Companion Flange Bolts

Section: Function Group 431

Years	Models
2021-2022	VNRe

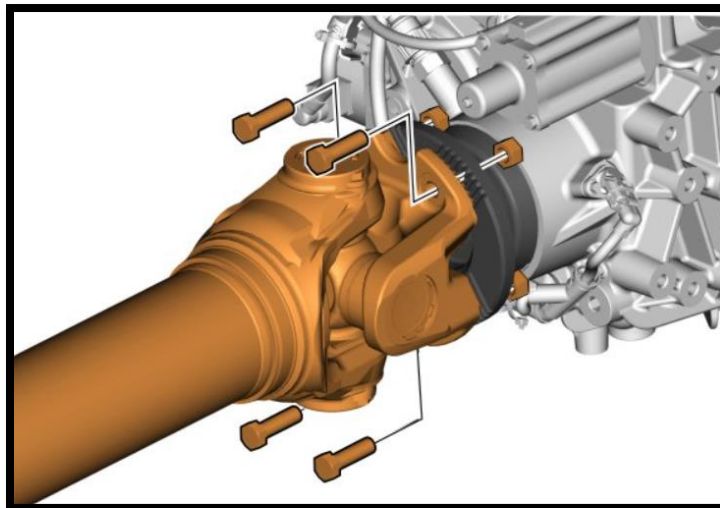
Volvo Trucks has determined that certain VNRe model vehicles were built with the incorrect companion flange bolts causing inadequate thread engagement. Replacement of the incorrect companion flange bolts with longer bolts is needed. Please follow the instructions below to replace the bolts.

5. Remove the companion flange nuts and screws.
